CITY OF KETCHUM, IDAHO
PLANNING AND ZONING COMMISSION
Thursday, February 05, 2026, 4:30 PM
191 5th Street West, Ketchum, Idaho 83340

IN RE:)
)
Sawtooth Serenade) KETCHUM PLANNING AND ZONING COMMISSION
Design Review) FINDINGS OF FACT, CONCLUSIONS OF LAW, AND
Date: February 5, 2026) DECISION
)
File Number: P24-027)

PROJECT: Sawtooth Serenade

FILE NUMBER: P24-027

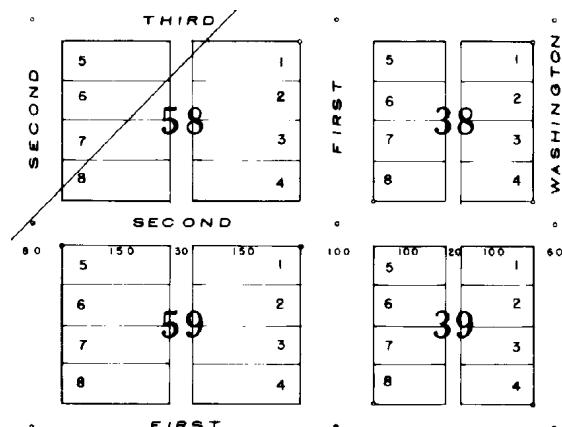
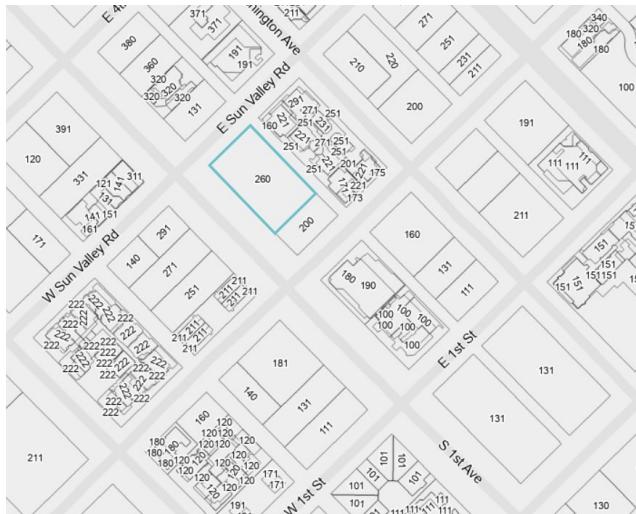
Finding: The Commission finds that the project as proposed lacks cohesiveness in architectural design, organizational hierarchy, design restraint, and deference to a main idea resulting in a structure that is convoluted and hectic from a design perspective. The design iterations proposed over the course of the three hearings have created a building that has too many architectural features that are disconnected from each other or a common design theme. Successful buildings deploy a design approach where architectural features come together in a cohesive way to create a character, which this proposed building is not doing successfully for the reasons outlined below.

On the north façade (Sun Valley Rd), the building contains an unorganized and confusing mixture of elements. This approach is unsuccessful and has resulted in a jumble of features unpleasing to the eye. As described in more detail below in the evaluation of 17.96.060.F.5 regarding bulk and flatness, early iterations of the design featured a bay window at the third floor that was bulky and ungrounded as it was floating in space and not aligned with other elements on the façade. The feature had the perception of an overlook that appeared to project above the street. The final version of the design removed the bay window but added a slanted roof to the first floor and third floor of the building. The Commission noted that the applicant exchanged one incongruous feature (the bay window) with another incongruous feature (slanted roof forms), neither of which were reflected in other portions of the building. The isolated use of these features caused the Commission to reiterate that the overall building design lacked a sense of hierarchy and cohesiveness necessary to establish a clear character.

On the west facade (N 1st Ave), the project includes a varied use of sunshade awnings, window detailing, projections and recessions, and vertical and horizontal elements that lack rhythm and purpose. The Commission noted that the amount of projections and recessions in concert with the horizontal and vertical elements eliminates the clear definition of character as no one element is a common denominator, anchoring the rest of the design and creating a hierarchy of features.

The Applicant contended that the varied use of certain angled roofs, sunshade awnings, recessions and projections, and vertical and horizontal elements created variation to break up the mass and bulk of the building. The Applicant also contended that the north facade, as proposed, was complimentary of the rest of the building and did not agree with the Commission's assessment that it lacked cohesion with the rest of the building. Changes to the north facade focused on the reduction of the bulk and mass rather than the architectural features. The Applicant also contested that there was hierarchy to the placement of the vertical and horizontal elements and that the features were used to differentiate the north side from the south side of the structure as viewed from N 1st Ave. The Commission expressed that while those features used with restraint may be an effective way of reducing the bulk and mass of the building, that the inconsistent and frequency of such in varying areas of the building led to dissonance and incongruity. Upon the weighing of such evidence, the Commissions finds that the building hierarchy lacks cohesion to clearly define building character and therefore does not meet this criterion.

Finding: During the review of the preapplication, the Commission expressed concerns related to the bulk and flatness of the building due to the amount of glazing, the length of the building, and the repetitive nature of the architectural design on the 2nd and 3rd floor levels. The Commission specifically noted the extent of the horizontal elements of the building and the mirroring of the north and south portions of the building that created the appearance of one large, long, flat building. The Commission requested the applicant take a closer look at how the building could be broken up to reduce the bulk and mass of the structure, including the recommendation to design the project as if it were two separate buildings with different design approaches. As the subject property is three Ketchum Townsite lots, and the building is maximizing the allowable north/south footprint, the resulting building is 165 feet long on the N 1st Ave side. The Commission acknowledged the challenge of reducing the bulk and mass of a building of this size and noted that the reduction of bulk and mass of buildings spanning three Ketchum townsite lots is critically important for new development, more so than developments on a single or double Ketchum Townsite lot, and that unique design approaches may be necessary to effectively reduce the appearance of the bulk and mass of the building.

In the first design review hearing, the Commission repeated comments related to the bulk and mass of the structure noting that although there is a wedding cake approach to the building from front to back (1st Ave to the alley) the building does not deploy a successful approach in reducing the bulk and mass from north to south (Sun Valley Rd to 2nd St). The proposal still appeared as one long, flat building primarily due to the long horizontal cantilevered decks, large windows, and long flat rooflines that were mirrored on the north and south portions of the building flanking the central staircase. The Commission found that the symmetry and banding and flat roof lines of the building exacerbate the bulk and mass of the building and efforts to reduce the bulk and mass by simply removing small amounts of square footage from the building at the corners were not effective. The Commission again requested the applicant revise the design approach to better match the context of the surrounding area by creating the appearance of multiple buildings. Below are images of the three design iterations of the west façade (N 1st Ave). The first image is the pre-application design review, the second image is the revised proposal presented in February 2025, and the third image is the final design proposal.

As clearly shown in the images above, the repetitive nature of the horizontal features including the cantilevered decks, flat rooflines, and amount of windows did not dramatically change from the first proposal to the last and did not address the Commission's concerns about how those features contribute to the long and flat appearance of the building. The Commission found that the Applicant did not sufficiently evaluate the option of designing two separate buildings attached by a center party-wall and that the minor changes to where certain materials were applied, addition of sunshade awnings, further stepback of sections of the façade, and removal of certain decks did not address the concerns related to the bulk and flatness of the building as viewed from N 1st Ave.

The Commission also requested the applicant address design concerns on the north and south facades of the building. The image below shows the three iterations of the north façade (Sun Valley Rd). Initial comments from the Commission at the pre-app noted that the pop out bay window at the third floor was bulky and ungrounded as it was floating in space and not aligned with other elements on the façade such as adjacent windows or horizontal and vertical elements on the façade. The Commission also noted that the remaining elements on the third floor were flat with little ornamentation around windows or at the roofline. The comments also noted that the façade was bulky due to the recession of the patio at the second level and that a better approach would be a wedding cake approach where the building stepped back (south) as the height increased.

The second iteration did not make revisions to the bay window, the second floor recession or the setback of the third floor on the Sun Valley Rd side of the building. The applicant reduced the overall height of the roof at the north end of the building and made a change to the upper floor window. The Commission acknowledged the improvement made to the overall height of the building but reiterated that by not addressing the bay window and the second floor recession that the façade was still ungrounded and the third floor accentuated the size of the building because it projected over the second floor. The final design iteration removed the bay window, but did not address the recession of the second floor. Furthermore, the applicant introduced a slanted roof that increased the height of the structure from the second proposal and introduced an angled architectural feature to the building that did not exist before and was not replicated in other areas of the project. This change increased the amount of the building façade that was open and flat to a degree similar to that of the first design iteration, which the Commission found to be a reversion in the design direction and counter to the comments provided.
